**NOTICE OF
COUNCIL ASSESSMENT PANEL MEETING**

**CITY OF MARION
COUNCIL ASSESSMENT PANEL AGENDA
FOR MEETING TO BE HELD ON
WEDNESDAY 07 JULY 2021
COMMENCING AT 6.30PM**

**3.1 DEVELOPMENT NO 100/2021/0178
10 GULFVIEW ROAD, SEAVIEW DOWNS
SINGLE STOREY SPLIT-LEVEL DETACHED DWELLING WITH ASSOCIATED
EARTHWORKS, RETAINING WALLS AND FENCING
Report Reference: CAP070721 - 3.1.....2**

**3.2 DEVELOPMENT NO 100/2021/0038
66 WHEATON STREET, SOUTH PLYMPTON
TWO SINGLE STOREY DWELLINGS
Report Reference: CAP070721 - 3.2.....23**

Figure 6 East Elevation – Portion of wall (depicted in blue hatch) which exceeds 3m in height

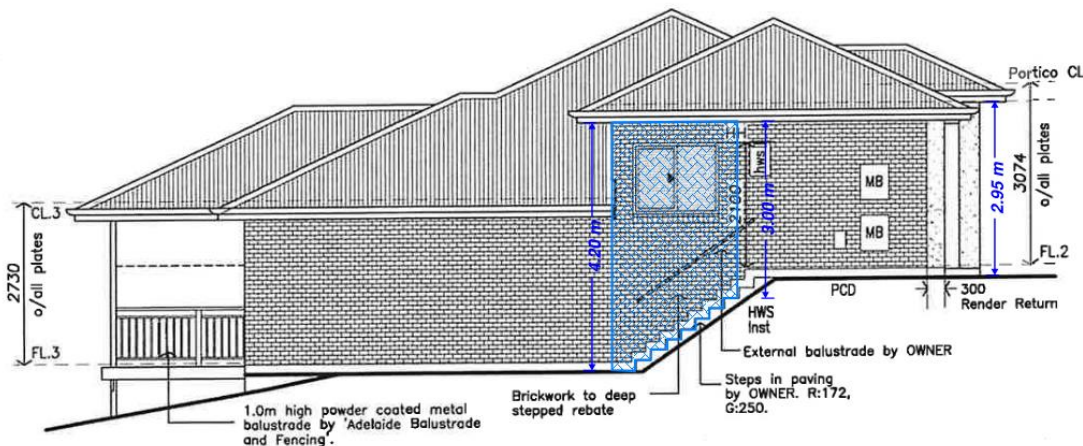
The proposed dwelling presents to the street as a modest single storey development. The topography of the land slopes down toward the northern/rear aspect of the site. The proposal complements the natural topography as a result of the split-level design. The non-complying trigger specifies that the vertical distance of wall should be limited in height. Specifically, the exception to this trigger is if *'the top of any external wall (to) the finished ground level immediately below that point on the wall is less than three metres.'* The dwelling's wall height exceeds 3 metres and at its highest point is 4.2 metres. The portion of wall which exceeds the 3 metres is only 2.1 metres in length and is illustrated in the images below.

Principle 2 of the Hills Face Zone also states that '*development listed as non-complying is generally inappropriate*'. When considering the extent of the walls which exceed 3 metres in height, it is viewed as inconsequential in relation to the overall design which complements the slope of the land, minimising impacts upon adjoining land. These wall elements, which trigger the non-complying status are located on the east and west sides of the dwelling and are adjacent to the neighbouring dwellings' side walls. The adjacent dwelling to the east exhibits a blank side wall and to the west the adjacent dwelling presents a two storey wall. As such, the impact of the wall heights greater than 3 metres is considered negligible in this context and the appearance of a single storey dwelling is maintained. Furthermore, the outlook of the proposed dwelling and surrounding dwellings in the locality is directed toward the northern aspect which affords cityscape and ocean views. The side walls do not impede these views and therefore are also considered appropriate.

Only a minor portion of the dwelling wall exceeds 3 metres and comes as a result of the split level design, which in part, assist in minimising earthworks throughout the land which is encouraged by the Hills Face Zone. To this end, the proposal is considered to result in appropriate outcomes for the subject land.

Figure 8 Siteworks & Drainage Plan showing the extent of fill exceeding 1.5m (depicted in blue hatch)

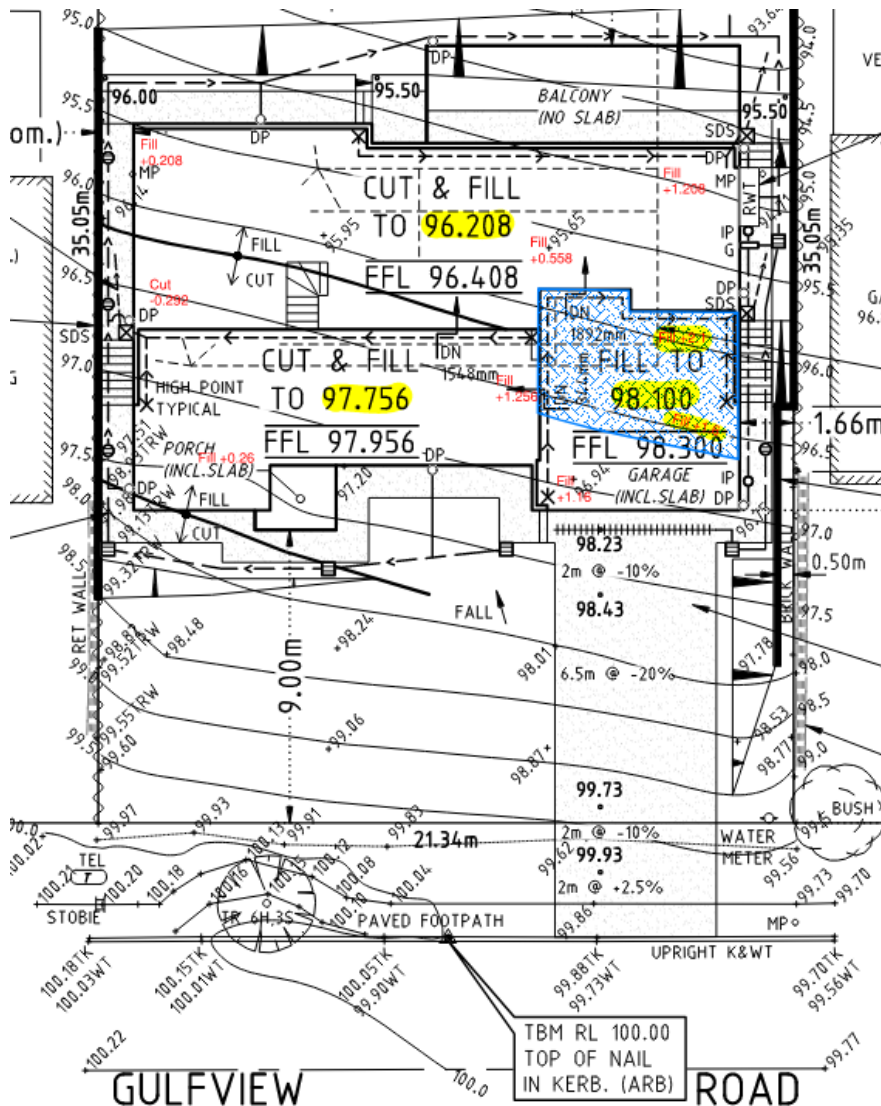
The non-complying trigger for excavation and filling applies if the depth or height exceeds 1.5 metres. The extent of fill required under the garage slab exceeds the 1.5 metres and reaches a maximum of 2.1 metres in the north-eastern corner of the garage. The portion of fill which triggers the non-complying status equates to 10 per cent of the total built floor area. The front façade of the dwelling has a consistent ceiling height line, however the finished floor level of the garage is slightly elevated and provides a 2.4 metre wall height, while the main portion of the dwelling has a ceiling height of 2.7 metres. This elevated floor level of the garage allows for a driveway gradient which is consistent with Council requirements. The proposed development's finished floor level (for the upper split level) is measured 1.92 metres below the street top of kerb level. When the proposed development is viewed from the street it will be sited below the road level minimising the visual impact of the building.

Although the dwelling will see an alteration to the natural land form, it is acknowledged the Zone identifies earthworks should only be undertaken in order to reduce the visual impact of buildings. The split-level design assists in achieving a built form complementary to the contours of the land and minimises the visual impact of the building; however, results in the earthworks up to 2.1 metres. This notwithstanding, it is acknowledged the land is nestled within an existing residential setting and other dwellings, such that the proposed earthworks are generally concealed within the site. The earthworks should therefore maintain the existing natural backdrop when viewed from the wider locality and plains.

The earthworks are not considered to result in a loss in amenity from adjoining land or the surrounding locality as it will be contained within the development area and have limited presence when viewed from public space. This development area is largely screened as a result of the proposed built form. When considering the development in relation to the natural topography and how it is sited proportionately on the land the excess of fill is considered to be acceptable.

Figure 10 Front elevation - Finished floor level in relation to street level and adjoining finished floor levels

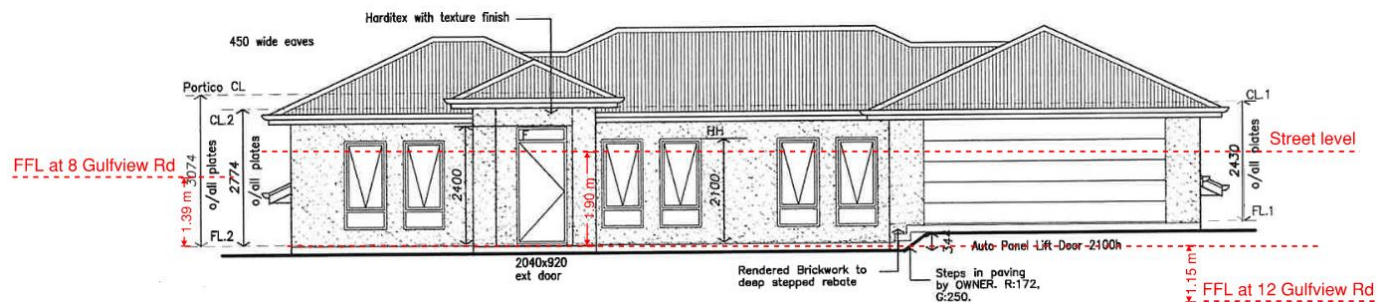
The proposed dwelling is located proportionally in between the finished floor levels of the adjacent dwellings. The established dwelling to the west of the subject site has a finished floor level which is 1.39 metres higher and to the east the existing dwelling is set down 1.15 metres lower. Furthermore, the proposed dwelling is to be situated lower than the street level and is to be 1.92 metres below the top of kerb level. This arrangement provides a natural transition in dwelling levels within the streetscape and complements the contours of the land.

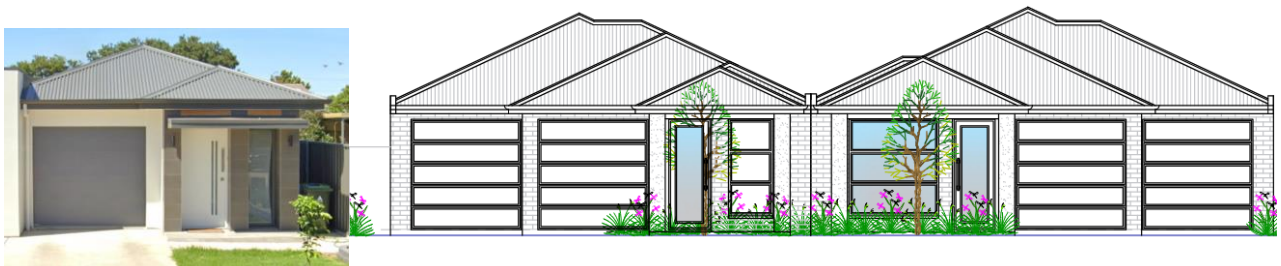
Despite this, the proposed garages are not considered to dominate the streetscape. While the proposed development does not 'minimise' the impact of garaging on the character of the locality as sought by Policy Area Objective 3, it demonstrates measures to mitigate any associated visual impacts and is considered to demonstrate good residential design principles.

- Each garage being split into two single openings and stepped accordingly;
- Garage setbacks being up to 2.5m behind the building line of the eastern adjoining dwelling;
- The garages being setback behind the proposed building line and projecting porch;
- Tapered driveways to reduce the extent of paved areas forward of the building line, with landscaping on both sides;
- The provision of landscaping forward of the building line including the planting of two *Magnolia grandiflora* trees per front yard which can reach significant growth heights.

Considered in more detail, the split in each garage breaks up the appearance of the garaging by separating the openings and stepping them at staggered setbacks. The roof form reflects this stepping and provides further articulation accordingly. Together with the garages being setback behind the building line of the associated dwelling and the eastern adjoining dwelling, these design techniques shall reduce the prominence of the garaging when viewed from the street.

Interpretation of Residential Development PDC 38 as it applies to semi-detached, row or residential flat dwellings.

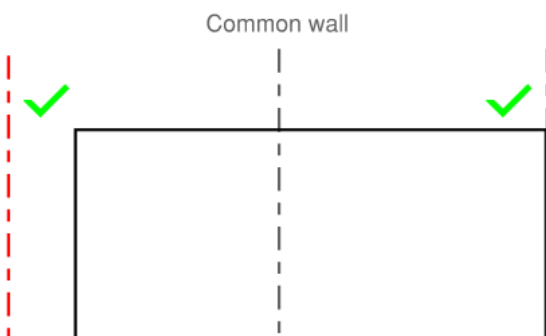
Residential Development Principle 38 states, '*Dwellings and associated garages and/or carports should only abut one side boundary (excluding common walls associated with semi-detached, row or residential flat dwellings)*'. It may be interpreted that Dwelling 2 does not satisfy this Principle by being constructed to both of its proposed side boundaries.

It should be noted that this Principle excludes common walls associated with semi-detached, row or residential flat dwellings. In practice, if such a dwelling type were proposed, this would enable the construction of the building to one external side boundary of the subject land, however not the other (as shown by the example below). This understanding of the criteria has resulted in numerous semi-detached or row dwelling developments across the Council area being constructed in this way. This is evidenced by several row dwelling developments in the locality, including the one immediately east of the land at 68 Wheaton Street (as pictured below).
